TECHNICAL LETTER REPORT
ON THE FOURTH 10-YEAR INTERVAL INSERVICE INSPECTION
REQUESTS FOR RELIEF
FOR
AMERGEN ENERGY COMPANY
OYSTER CREEK GENERATING STATION
DOCKET NUMBER: 50-219

3.2 Request for Relief OC-02-02, Examination Category B-K, Item B10.10, Welded Attachments for Vessels, Piping, Pumps and Valves, Reactor Pressure Vessel Support Skirt

ASME Figure IWB-2500-13, Integral Attachment Weld (typical).

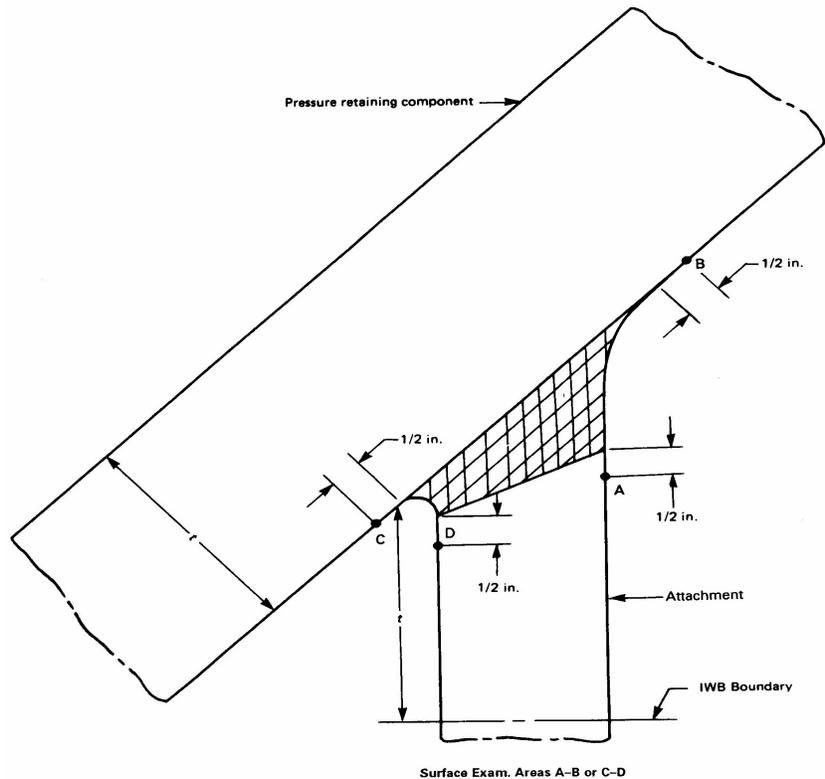
Pursuant to 10 CFR 50.55a(g)(5)(iii), relief is requested on the basis that the Code requirements to examine essentially 100% of the surface areas is impractical due to physical obstructions and geometric interference. Control rod drive housings and instrumentation penetrations restrict the examination of area C-D as required by Figure IWB-2500-13. The physical location of the drives and instrumentation penetrations, and the design of the vessel skirt, prohibit access to area C-D. Area A-B as shown in Figure IWB-2500-13 remains accessible for surface examination to the extent required by the Code.

In addition, Oyster Creek's nondestructive examination group pursued the use of an alternative ultrasonic examination method in lieu of the surface examination for area

C-D. As a result of this review, which considered the unique configuration of the Oyster Creek vessel skirt design, it was concluded that ultrasonics would not provide Code examination coverage. Compliance with the applicable Code requirements would require redesigning and modifying the RPV support skirt.

As an alternative to the Code requirement to perform a surface examination of areas A-B and C-D, AmerGen proposes to perform the following:

1. Perform a surface examination of area A-B as required by Table IWB-2500-1, Category B-K,
2. Perform a VT-3 visual examination of the support skirt IWB boundary as shown in Figure IWB-2500-13 for any support member deformation.

Actual configuration of Weld 1-569 showing areas to apply ultrasonic scans for the inside surface area C-D.

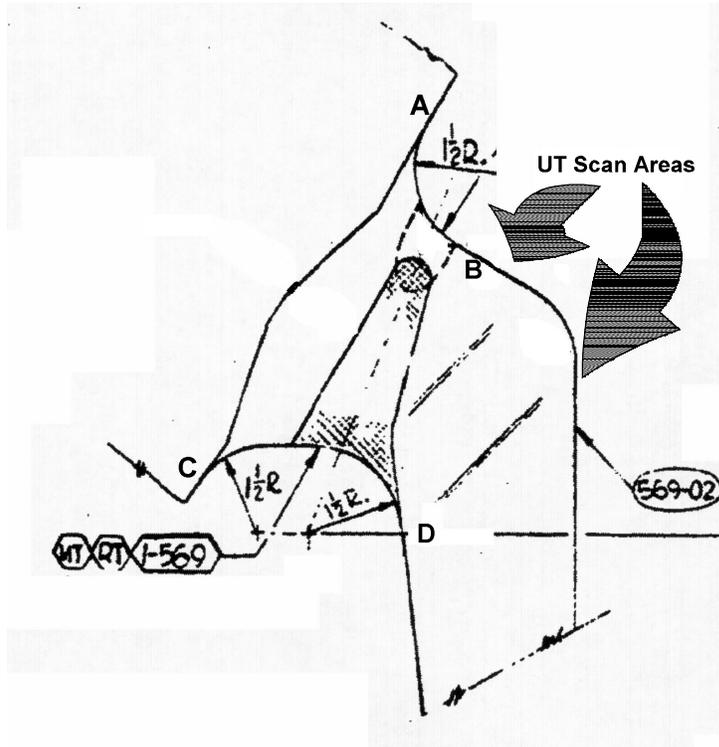
Evaluation: The Code requires the licensee to perform essentially 100% surface examination of both the inside and outside surfaces of reactor pressure vessel (RPV) support skirt Weld 1-569. However, access to the inside surface is severely restricted due the presence of control rod drive and in-core instrumentation housings and electrical lead conduits. In addition, no personnel entry or inspection ports are provided in the OCGS support skirt design. Therefore, surface examination of the inside surface is impractical. To gain access to perform limited surface examinations would require the licensee to make design modifications to the RPV support skirt. This would place a significant burden on the licensee.

The licensee is performing 100% of the Code-required surface examination on the outside surface of RPV support skirt Weld 1-569. The Code designates this outside surface of the integral attachment weld as area A-B, and the inside surface as area C-D. Areas A-B and C-D include the weld and ½-inch of base material on either side of the weld for each surface over the length of the weld (see Figure 2). The licensee has also proposed to perform a visual VT-3 of the outside surface of the IWB support boundary in order to detect deformation that might be manifested on this surface.

The inspections performed by the licensee should detect any degradation that might be present on the outside surface of RPV support skirt integral attachment Weld 1-569. However, their proposed alternative examination does not include any provisions for assuring gross degradation is not present on the inside surface of this weld. The licensee stated that an ultrasonic examination of the inside surface applied from the outside was considered, but that the 1-1/2-inch blend radius on the weld surface demonstrates limited capability to conduct this examination. Based on the drawings¹ provided by the licensee, it is the Staff's opinion that ultrasonic examination methods may indeed provide further information to ensure that inside surface-breaking flaws are not present. As shown in Figure 2, it appears that relatively simple techniques, applied from the outside surface in the areas above and below the support skirt "shoulder"

region should provide reasonable assurance that no significant structural discontinuities exist that may be generated from the inside surface of Weld 1-569. In fact, other licensee's are applying similar volumetric alternatives to examine the inside surface regions on RPV integral attachment welds.

The licensee has shown that it is impractical to access the inside surface area C-D of RPV support skirt integral attachment Weld 1-569 for the Code-required surface examination. The licensee is able to obtain 100% of the Code-required surface examination of the outside surface area A-B, providing reasonable assurance that any flaws generated from the outside surface will be detected. However, the licensee's alternative, to perform a VT-3 visual inspection, of the outside IWB boundary region does not provide reasonable assurance that no inside surface flaws exist. Therefore, pursuant to 10 CFR 50.55a(g)(6)(i), it is recommended that the licensee's request be granted, with the provision that the licensee develop and implement ultrasonic techniques for detecting surface-breaking flaws on the inside surface region C-D of Weld 1-569.
